Subject: Exelon Nuclear Texas Holdings, LLC  
Victoria County Station Early Site Permit Application  
Response to Request for Additional Information Letter No. 09  
NRC Docket No. 52-042

Attached are responses to NRC staff questions included in Request for Additional Information (RAI) Letter No. 09, dated May 6, 2011, related to Early Site Permit Application (ESPA), Part 2, Sections 02.05.01 and 02.05.03. NRC RAI Letter No. 09 contained twenty-three (23) Questions. This submittal comprises a partial response to RAI Letter No. 09, and includes responses to the following eight (8) Questions:

Figure 1. VCS Site Area Map Illustrating Possible Geomap Fault Surface Projection Uncertainty.

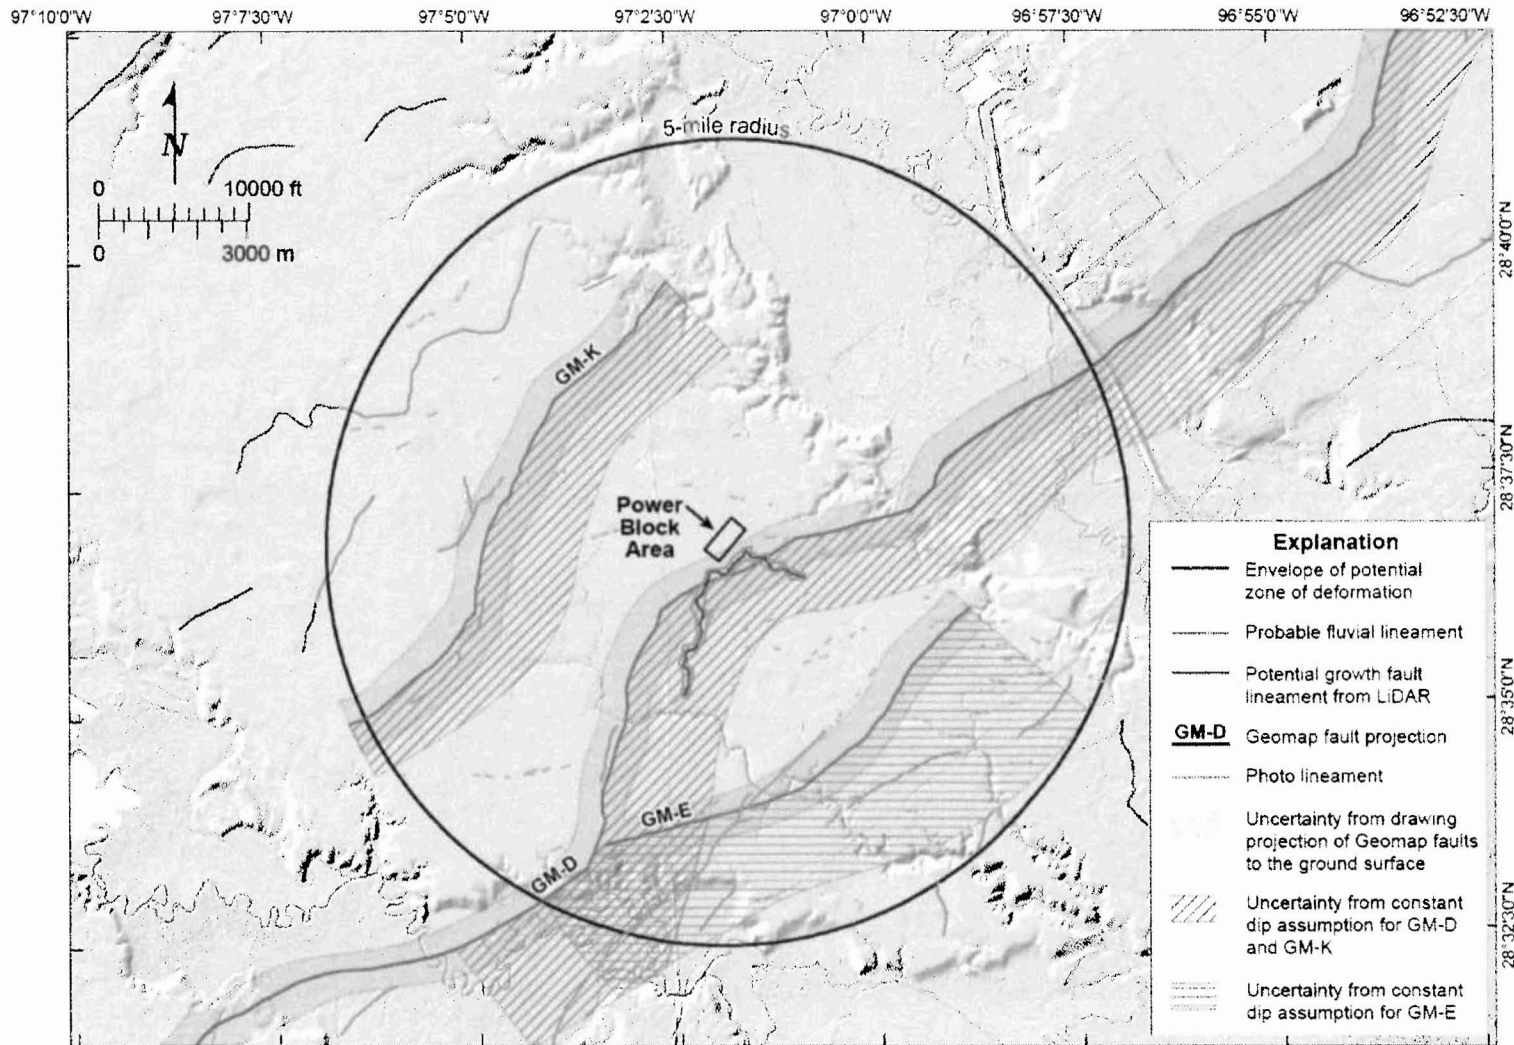
1. Please discuss fault location and fault correlation uncertainties with respect to all specific data sets and as an integrated whole.
2. Please provide a figure(s) to reflect the uncertainties (for example, adjusting the line widths).
3. Please discuss how these uncertainties impact your conclusion that no fault projects beneath the power block footprint.

It is difficult to evaluate any potential uncertainty in the fault locations at depth within the Geomap data due to the vast amounts of data (both proprietary and publicly available) that were used by the Geomap developers in compiling the maps. However, given the relatively dense well spacing within the site area, in particular surrounding growth faults GM-D and GM-E, it is likely that the growth faults are relatively well located. Therefore, for this analysis the locations of the faults at depth are assumed to be accurate, but it is important to note that the Geomap data were not used to as the primary basis for making conclusions regarding the potential for growth faults to cause surface deformation within the power block area (as discussed above). To estimate any potential uncertainty from drawing a smooth projection, an envelope was drawn surrounding the maximum extent of the projected points (Figure 1).

The uncertainty introduced by the constant dip assumption can be estimated by comparing the projection of the growth faults using the observed dips between the horizons and the maximum possible dip of a growth fault. The median dip determined from the Geomap data for the points along fault GM-D, GM-E, and GM-K are 73°, 68°, and 75°, respectively. Because growth faults are listric, the maximum dip any fault could have above the upper Geomap horizon is 90°. Therefore, the uncertainty in the constant dip assumption is represented by drawing an envelope around the projections that extends from the surface directly above the upper Geomap horizon (i.e., drawn from the upper horizon using a dip of 90°) to the projected surface assuming a constant dip (i.e., drawn from the upper horizon using the observed dips between the two Geomap horizons). These enveloping areas are presented in Figure 1. It should be noted that the projection for growth fault GM-K is purely hypothetical because there is conclusive evidence in the seismic reflection data and LiDAR data that growth fault K does not extend to or deform the surface.

It should be noted that uncertainties in the Geomap data indicate that growth fault D may project within the power block area (Figure 1). However, as discussed above the Geomap data are considerably less accurate than the seismic reflection data (for the ability to project faults to the surface) and the LiDAR data (for the ability to identify surface deformation potentially associated with growth faults), which constrain the zone of potential surface deformation associated with growth Fault D to outside of the power block area. Thus, the uncertainties associated with surface projection of the Geomap data do not impact the conclusion that no faults project within the power block area.

Figure 1 . Geologic Map within the 5-mile Radius.

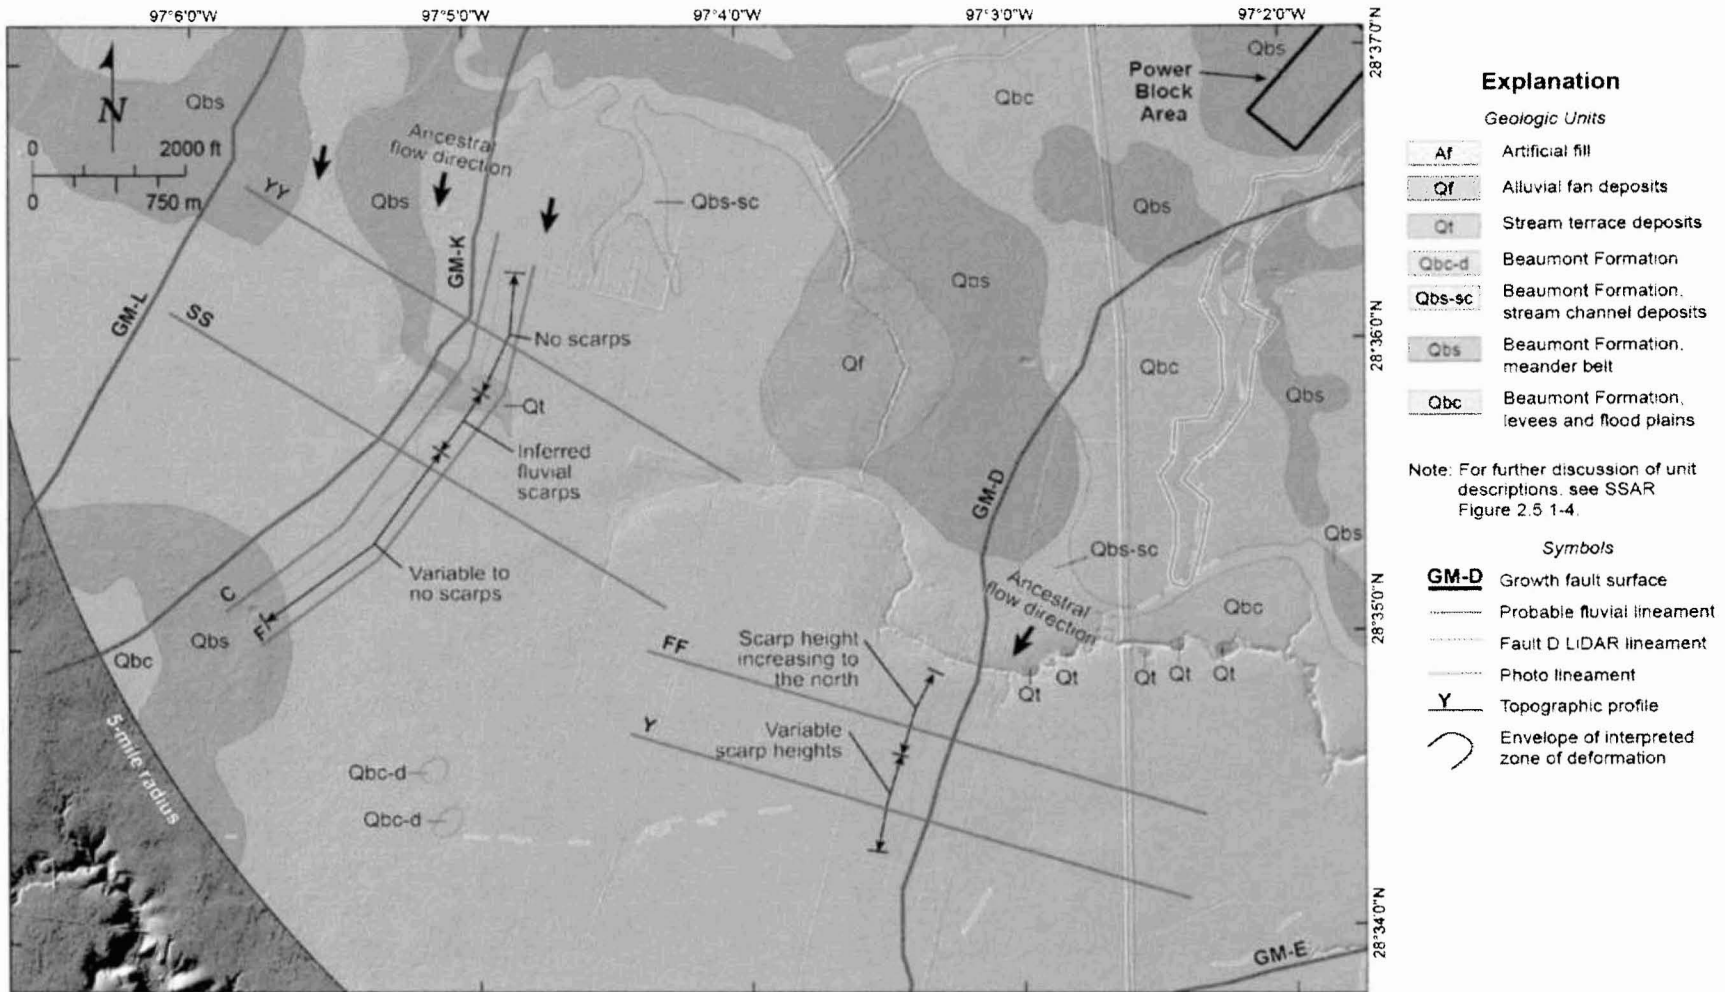
SSAR Section 2.5.1.2.4.2.2 describes criteria used to classify lineaments from airphoto and LiDAR data as related either to growth faulting or to non-tectonic processes. Many lineaments interpreted by you to be of fluvial origin (Figs. 2.5.1-37, 41, 42) lie near and on-trend with surface projections of faults K and D (**see attached Figure 1**). One lineament parallels fault K turn-for-turn for more than 3 km, yet is interpreted as fluvial in origin. Many lineaments interpreted as fluvial scarps trend nearly perpendicular to the regional slope and flow direction, and appear to be southeast-facing, consistent with the slip direction of growth faulting in the region. In support of 10 CFR 100.23 please discuss the alternative interpretation that many of these lineaments are surface manifestations of active growth faulting rather than fluvial processes, and the implications for site safety.

It is important to clarify that the lineaments shown on SSAR Figure 2.5.1-42 and in the NRC Figure 1 were not necessarily 'interpreted as fluvial scarps' but rather "Probable fluvial lineament(s)" and include features identified on aerial photography. For example, these lineaments coincide in places with inferred topographic features identified on LiDAR but do not consistently have surface expression or lateral continuity that can be attributed to the possible surface expression of growth fault deformation. In addition, although these lineaments locally have a different trend than the regional slope and flow direction, the orientation of the features are consistent with the ancestral flow patterns inferred from subtle paleochannels developed on geologic unit Qbs (Figure 1).

These lineaments that locally coincide with mapped inset fluvial terraces that do not support the interpretation that these lineaments are related to growth faulting (Figure 1). For example, the back edge of geologic unit Qt is coincident with the middle of, and parallel to, the lineament adjacent to the surface projection of growth fault GM-K (see Figure 1). If active growth faulting is occurring across this lineament, it is expected that terrace development and stream incision to have occurred in the inferred area of uplift west of the lineament, not downstream of the lineament in the inferred area of subsidence. Similarly, stream incision and terraces are observed downstream of the lineament that is partially coincident with the surface projection of growth fault GM-D (Figure 1). This observed pattern is the opposite of that expected across the general up-on-the-west displacements of growth faults in the VCS site vicinity. More importantly, the associated fluvial scarps are coincident with other inferred fluvial features identified along the lineaments.

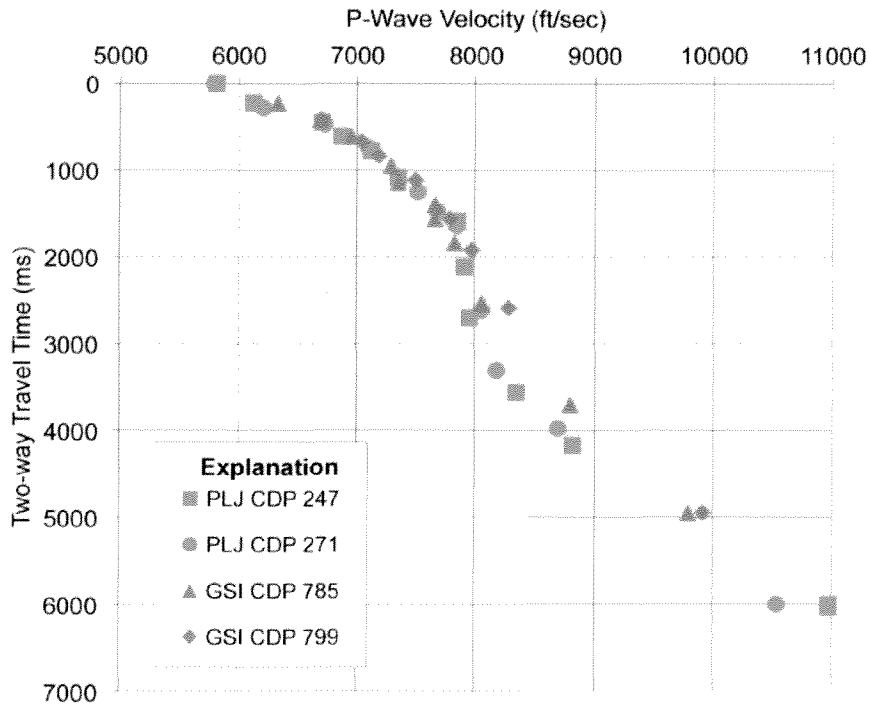
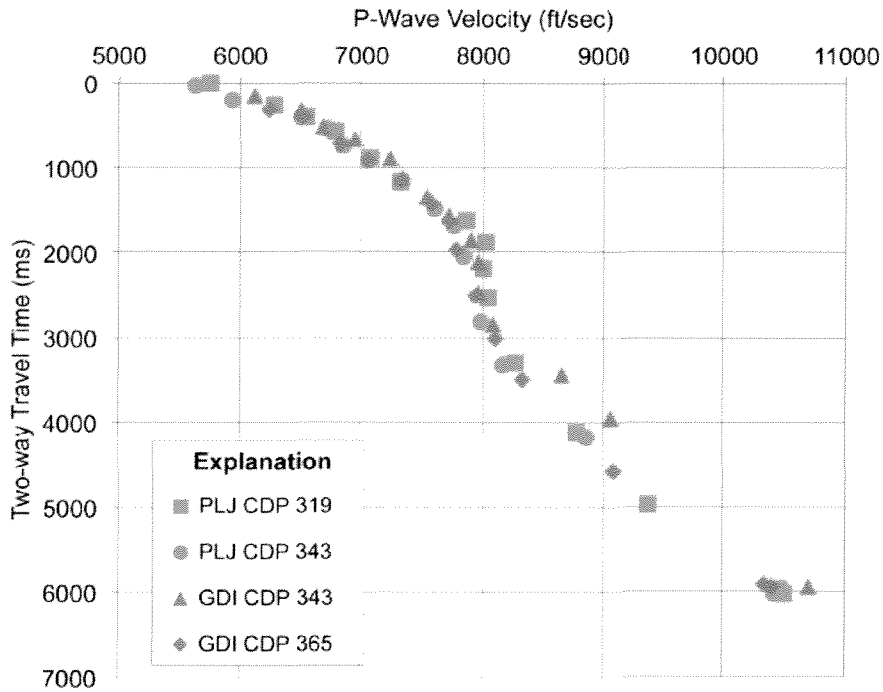
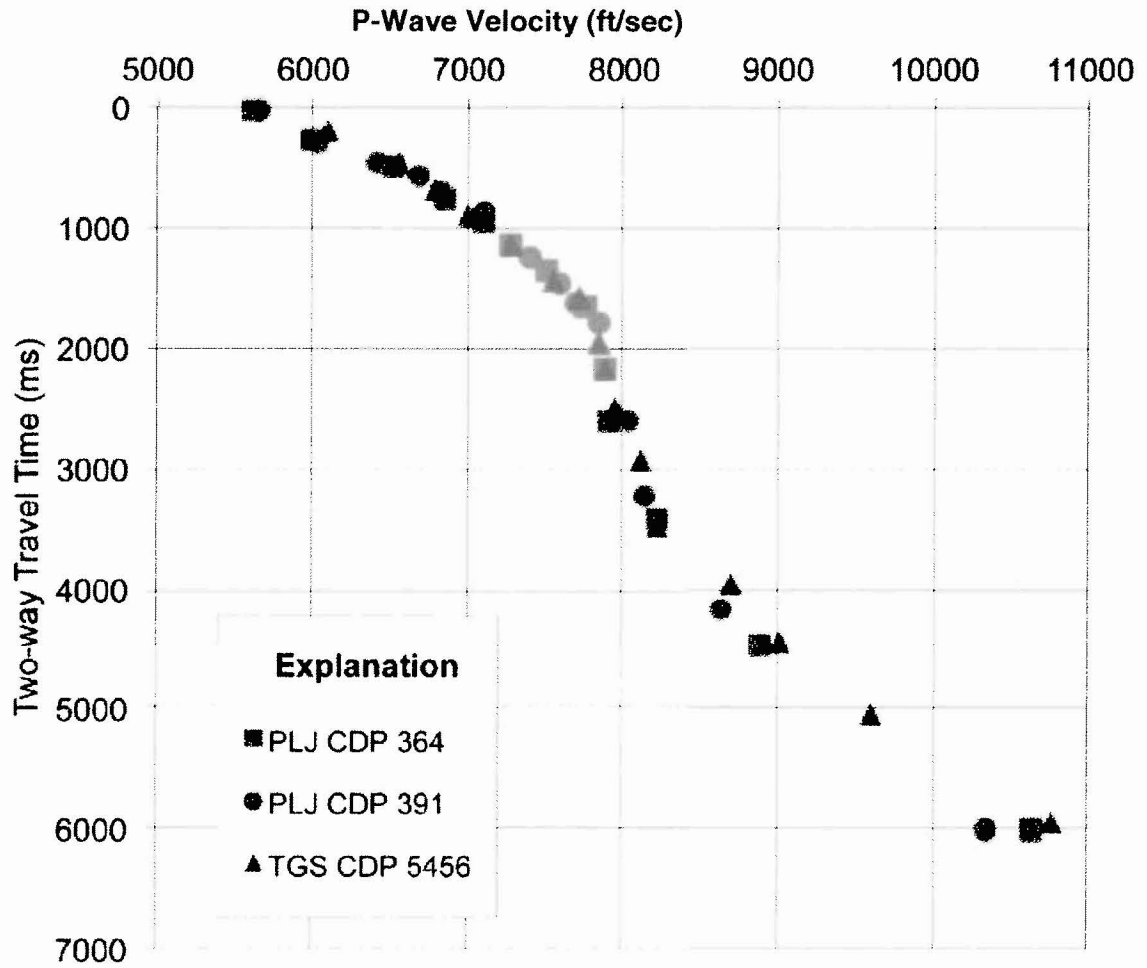
- Provide a discussion on the limitations of this dataset for characterizing growth faults in the VCNPP vicinity
- Describe comparisons of the stacking velocity fields at the profile tie points, and discuss your level of confidence in the interpreted velocity structure
- Describe how sonic log data from deep wells drilled in the vicinity of the VCS site were used in the seismic reflection velocity analysis. For example, were they incorporated directly into the processing or were they compared to the processing-derived velocity field as a quality check?

For each seismic reflection line, the line's interactive stacking-velocity analyses functions are indexed by Common Depth Point (CDP). Selected CDPs were used as the stacking velocity functions for the line. Figures 1a, b, and c show the stacking velocity functions for the CDPs bracketing the intersection of tie-line PLJ with lines GSI, GDI and TGS. The PLJ-GSI intersection occurs between CDPs 247 and 271 for line PLJ and between CDPs 785 and 799 for GSI (Figure 1a). The PLJ-GDI intersection occurs between CDPs 319 and 343 for line PLJ and between 343 and 365 for line GDI (Figure 1b). The PLJ-TGS intersection occurs between CDPs 364 and 391 on line PLJ and at CDP 5456 for line TGS (Figure 1c). The distance between the bounding velocity functions varies between lines, but is between approximately 0.5 km to 1 km. Figure 1 demonstrates that the stacking velocities are consistent at the intersection points (e.g., tie points), especially above 4 seconds where most of the interpreted structure is mapped (see SSAR Figures 2.5.1-45 through 2.5.1-47).

Figure 1. Color Shaded Relief Map of LiDAR Data Adjacent to the VCS Site Showing Location of Topographic Profiles.

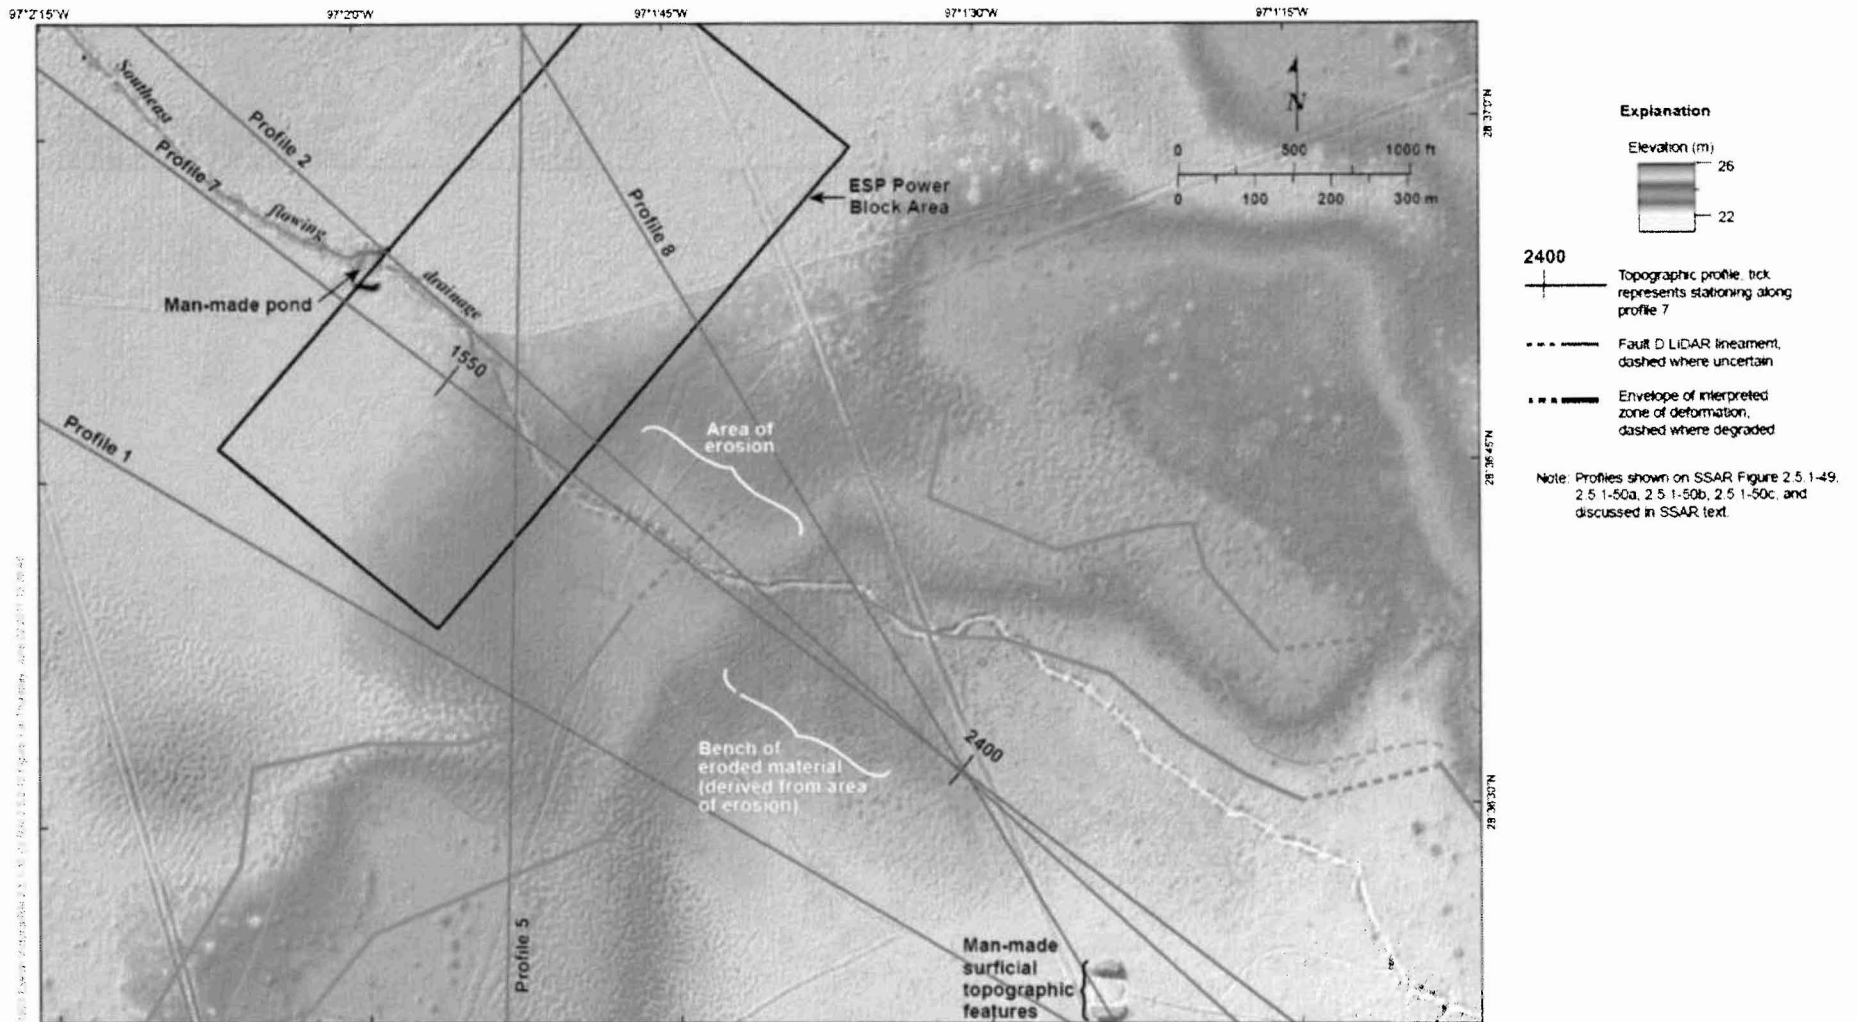
1. Please explain your justification for defining the boundary of the zone of deformation as the shaded triangle, as interpreted in the Figure 2.5.1-48, rather than the wider zone of deformation postulated above.
2. Please explain how you used the surficial topographic (LiDAR) data to define your interpreted zone of deformation. Also, please explain how the topography could be used to preclude the existence of a wider zone of deformation associated with fault D.
3. Please provide further justification for your interpretation that the lack of a topography break in LiDAR Profile 7 can be attributed to geomorphic or cultural processes rather than a wider zone of deformation between marker 1550 m southeastward to 2400 m, which encompasses the proposed location of Unit 1.

(3) As summarized as part of section (2) of this response, the zone enveloping the interpreted extent of tilting or folding associated with post-Beaumont activity of growth fault D was developed by analyzing a suite of over 90 LiDAR topographic profiles (SSAR Figure 2.5.1-49) rather than interpreting each topographic profile separately without regard to the overall local geomorphic/cultural setting. Figure 1 was developed to help illustrate the importance of the local setting when interpreting topographic profiles and to help answer the question posed by the NRC above. This figure illustrates the following:

The color shaded relief map of LiDAR data illustrates several important geomorphic features, including: 1) a southeast-flowing drainage (marked by a geomorphically distinct channel) through the power block area, 2) a series of small topographic bumps along the margins of the channel (suggest the channel has been deepened to improve drainage) and 3) a 'benched' area just south of the zone of deformation subparallel to the axis of the larger drainage (see SSAR subsection 2.5.1.2.4.2.3.2 for a detailed explanation of interpreted 'benched' areas).

As discussed in SSAR subsection 2.5.1.2.4.2.3.2, profile 7 runs through the middle of the southeast-flowing drainage that parallels a broad southeast-sloping topographic low, which has caused erosional degradation of the interpreted zone of deformation associated with growth fault D. In addition, profile 7 is located almost directly coincident with the distinct channel that has been anthropogenically modified near the southeastern and northwestern border of the power block area. The topographic expression of the zone of deformation is more distinct in profile 8, marking the eastern edge of the degraded zone in Figure 1. Likewise, comparison of profiles 7 (degraded) and profile 8 (distinct) suggest that erosion and 'benching' of profile 7 has occurred (see discussion of erosion and benching between profiles 7 and 8 in SSAR subsection 2.5.1.2.4.2.3.2 for further discussion). Thus, the most reasonable explanation of the topographic data is that the broad southeast-trending drainage has caused the muted expression of surface deformation associated with growth fault D along profile 7.
